TECHNICAL SERVICE BULLETIN

Technical Service Bulletin: 225-0970

Forest River is alerting you to an issue involving certain 2018 through 2019 – Crossfit – CFB22CF, CFB22CFEB, CFB22CFEBCA, CFB22DF, CFB22DFEB Class B motorhome recreational vehicles. Please see the information below which describes the issue and provides you with details on the steps you should take to have your vehicle repaired.

CORRECT INSTALLATION VALIDATION PROCEDURE • 02/19/2019

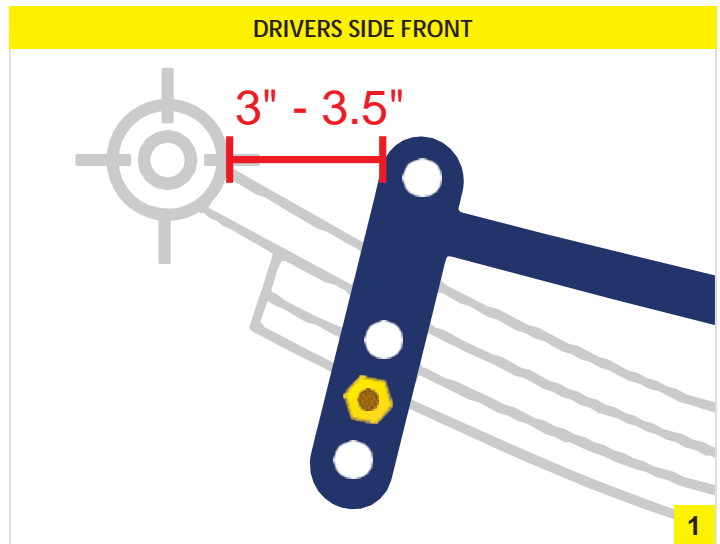
It has been reported that the SuperSprings may interfere with the Ford Transit 350 vehicle chassis rear factory spring hanger when incorrectly installed. This interference can result in a mechanical noise when fully loaded and hitting a severe pothole or speed bump.

To ensure proper positioning, the measurement of space between the front of the SuperSprings and the rear of the vehicle front spring eye is necessary. This dimension should be no less than 3.00" and must not exceed 3.5" (SEE IMAGE 1). If the measurement is within this range, then no further action is required. If this measurement is outside of this range then corrective action is required – refer to:

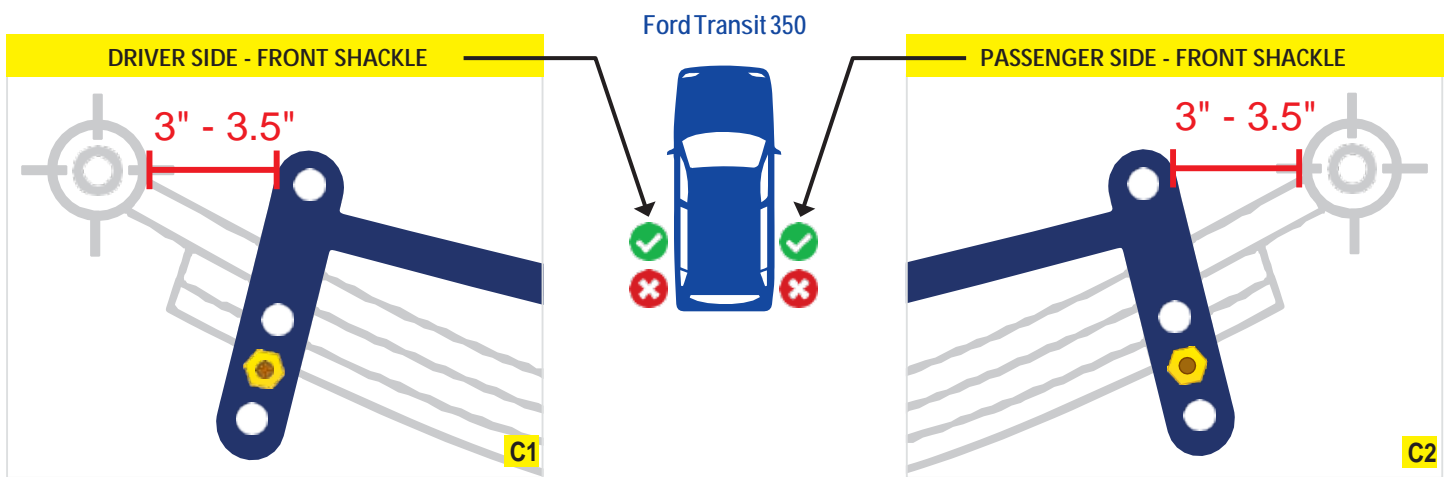
- A. Using a ½" wrench and socket loosen the attaching bolt on the poly spring pad lock down clamp located at the center of the SuperSprings. Do not remove hardware. (SEE IMAGE A)
- B. Place a pry bar behind the rear of the SuperSprings with the end against the cross member. (SEE IMAGE B)

- C. Push the SuperSprings forward with the pry bar to obtain a measurement of 3" to 3.5" between the front of the SuperSprings and the rear of the vehicle front spring eye. (SEE IMAGE C1 AND C2)
 - D. Using a ½" wrench and socket retighten the attaching bolt on the poly spring pad lock down clamp located at the center of the SuperSprings originally loosened during step 3-A.
4. Repeat the same process on the other side if necessary.
 5. **LOWER THE VEHICLE**
Jack up the vehicle, remove the jack stands, and then lower the vehicle to the ground. Remove the blocks from front and rear of the front wheels.
